TX650, TX650A and XS Series

BRONZE SWING ARM BUSHINGS

**THIS BULLETIN TAKES THE PLACE
OF No. 398. DESTROY M/C PNB No. 398.**

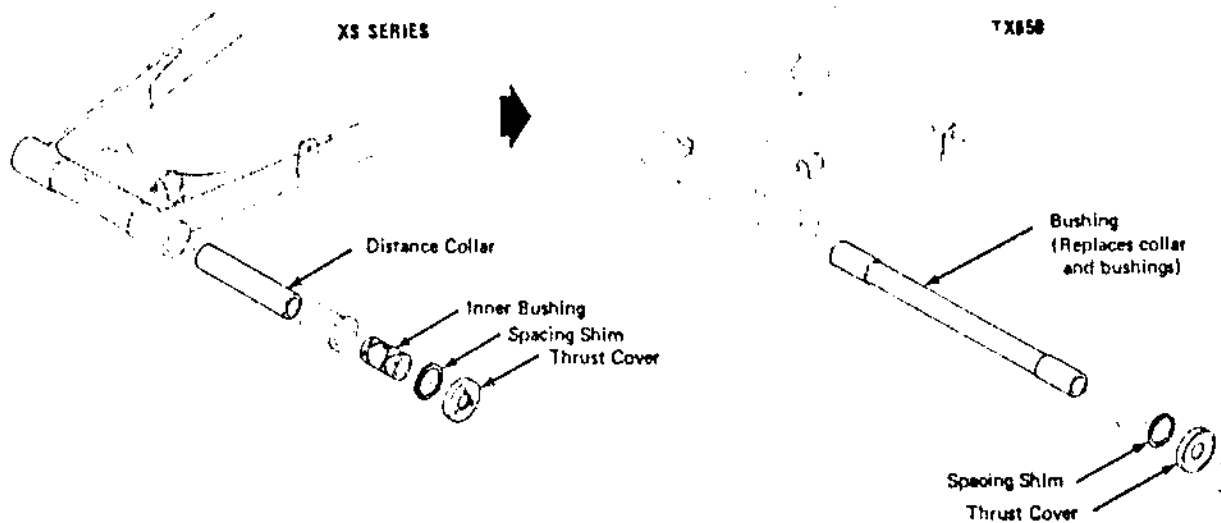
The part number for the bronze swing arm bushing shown in Motorcycle Parts News Bulletin No. 321 has been changed.

The bronze bushing is an accessory item and is not used in production. They can be installed on any XS1, XS1B, XS2, TX650 or TX650A to minimize swing arm free play.

NOTE: When installing bronze bushings on XS1's, XS1B's and XS2's, the inner bushings, the distance collar and the thrust covers must be replaced with TX650 parts.

CAUTION: Always check swing arm side play and add or remove spacing shims (P/N 240-22127-00-00) to allow .005 in. side play. See Motorcycle Parts News Bulletin No. 262 for measurement procedure.
